Model: Bellini-C3 (Katana)	Date: 11-May-06	No.: RB234001b
----------------------------	-----------------	----------------

Subject: Controller firmware (Animation) release note for B-C3		Prepared by: T.Tadokoro	
From: PPBG QA/Service Planning Dept.			
Classification:	<input type="checkbox"/> Troubleshooting	<input type="checkbox"/> Part information	<input type="checkbox"/> Action required
	<input type="checkbox"/> Mechanical	<input type="checkbox"/> Electrical	<input type="checkbox"/> Service manual revision
	<input type="checkbox"/> Paper path	<input type="checkbox"/> Transmit/receive	<input type="checkbox"/> Retrofit information
	<input type="checkbox"/> Product Safety	<input type="checkbox"/> Other (     )

Model: Katana	Date:14-Jul-06	No.: RB234015
---------------	----------------	---------------

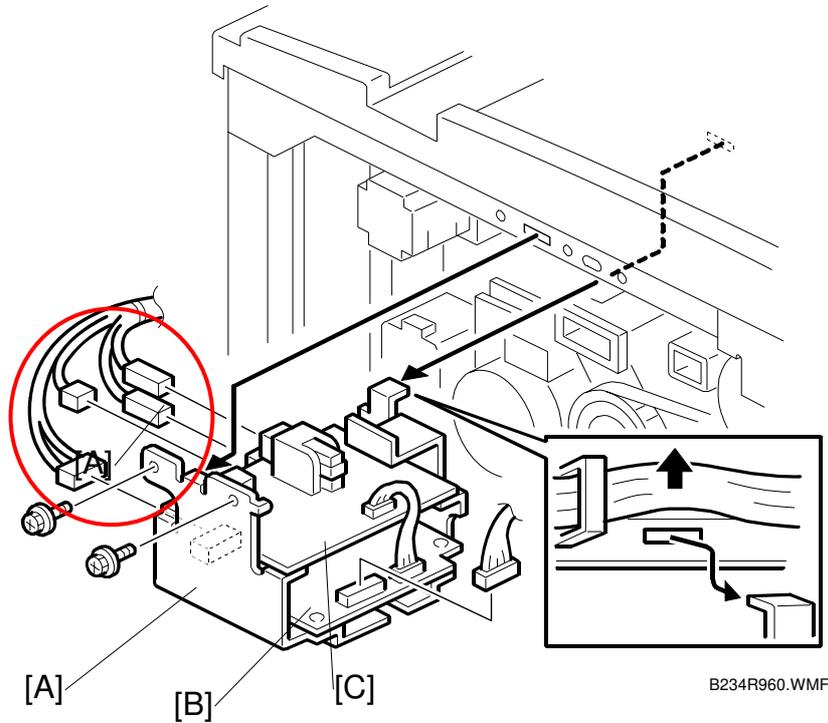
Hot roller gears	C/L			Lubricate (Barrierta 55L or SS552R)
------------------	-----	--	--	-------------------------------------

Hot roller gears	C/L			Lubricate with <b>Grease Barrierta – JFE5 5/2</b> (A2579300)
------------------	-----	--	--	--

**8. Replace with new photo <B830-34>**

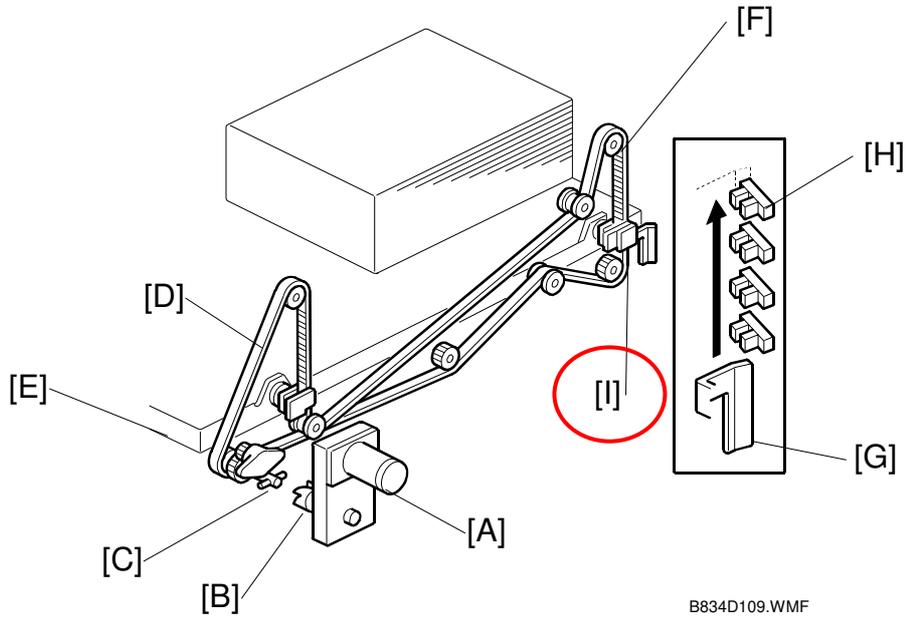
S38	Stapler Rotation Sensor 2	Paired with Stapler Rotation Sensor 1. This sensor pair controls the positioning of the corner stapler for the horizontal, 45° angle, and 75° angle stapling positions.
-----	---------------------------	---

S38	Stapler Rotation Sensor 2	Paired with Stapler Rotation Sensor 1. This sensor pair controls the positioning of the corner stapler for the <b><i>horizontal and 45° angle stapling positions.</i></b>
-----	---------------------------	---

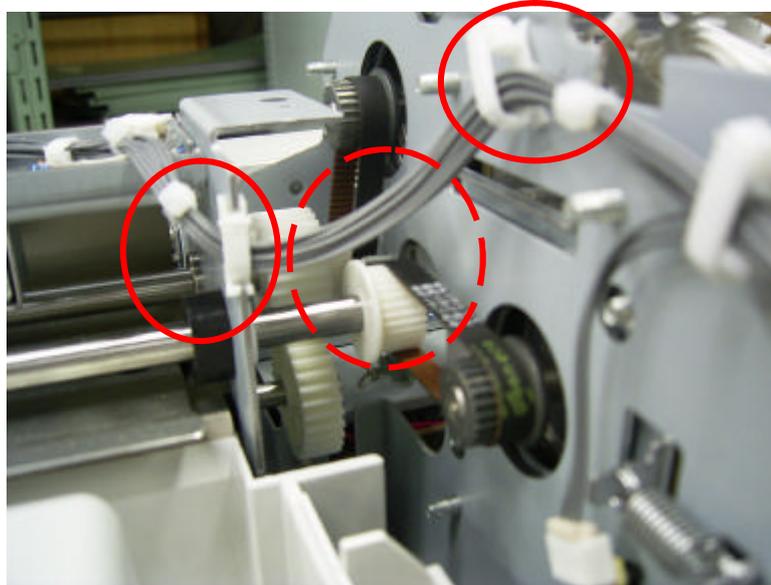
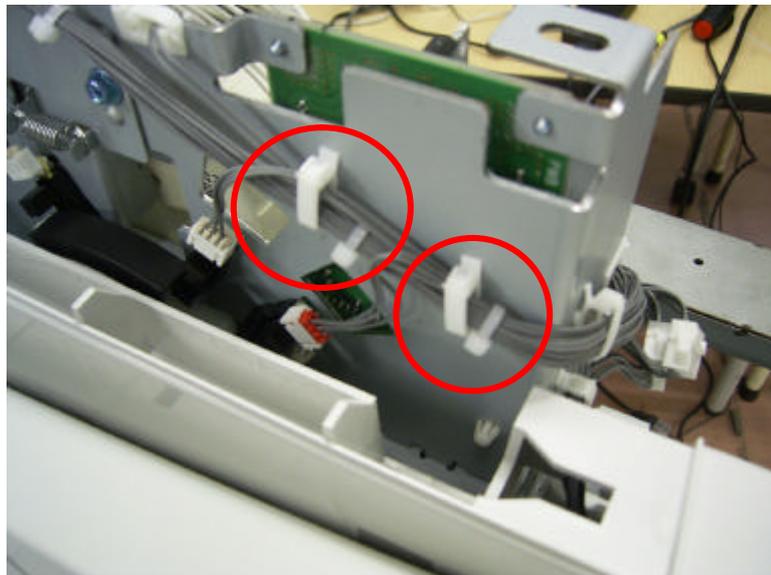
The harness touches the belt.

1. Make sure the harness clamps and binds are in the position shown in the photo (see right and left red circles).
2. Make sure the harness does not touch the belt (see center red circle).

3. Make sure the harness clamps and bindings are in the position shown in the photo (see red circles).

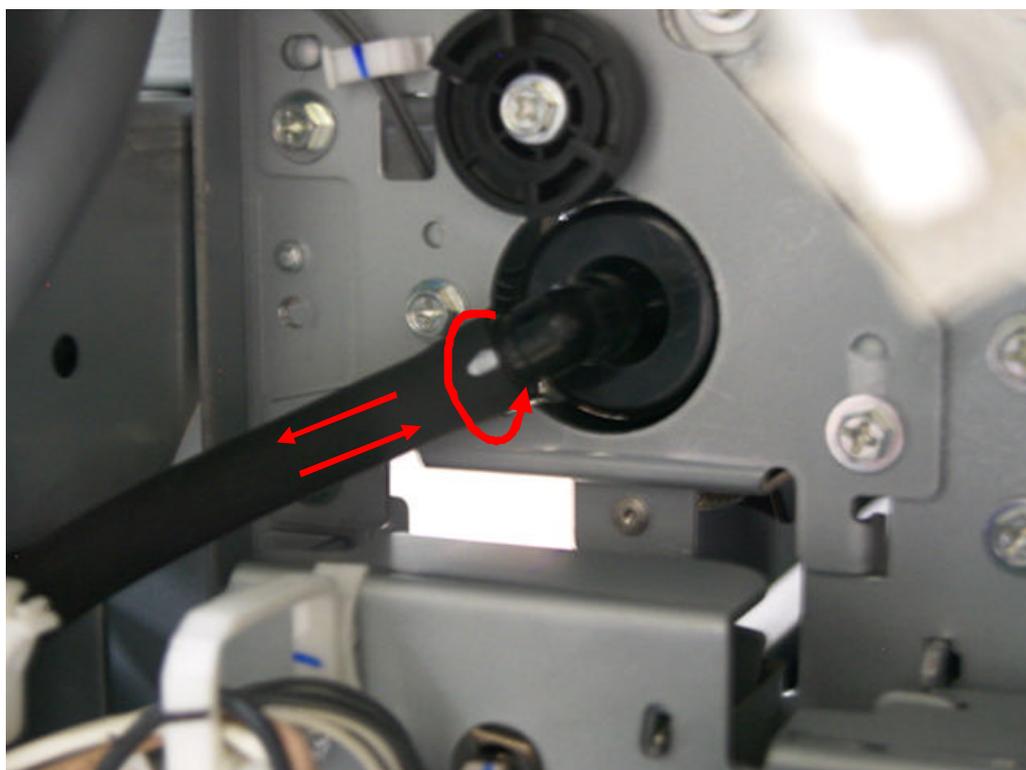
1. Remove the toner pump motor unit (screw x 3, connector x 1).
2. Disconnect the tube, turn it 180 degrees to straighten it, and then reattach it (**see the photo below**).

**Important:** Position the tube to the **left of the connector** shown in the photo above.

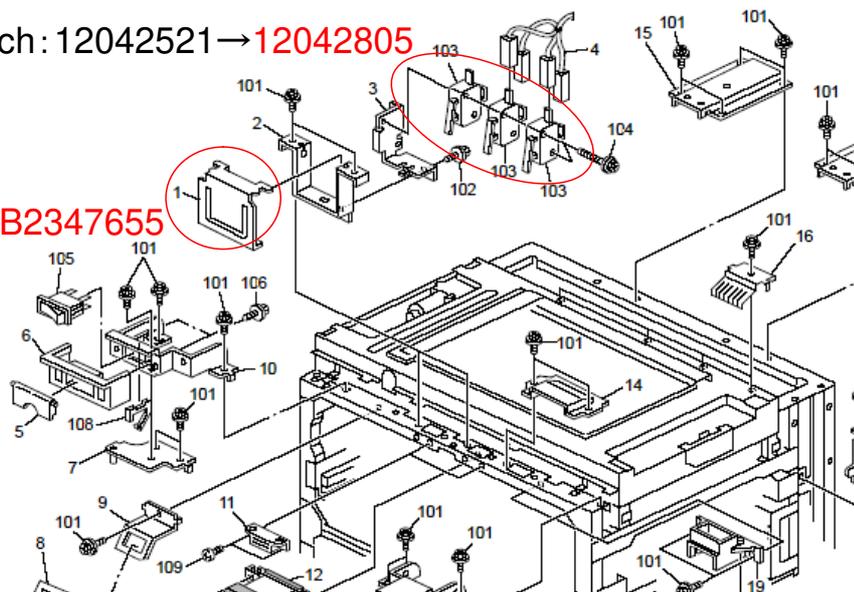
When replacing the Front Door Safety Switch, please be further advised below.

Since the Switch was replaced, the part number of the Switch has been changed from "12042521" to "12042805." Simultaneously the Lever has also been changed from "B2347653" to "B2347655". Combination exists between the Switch and the Lever.
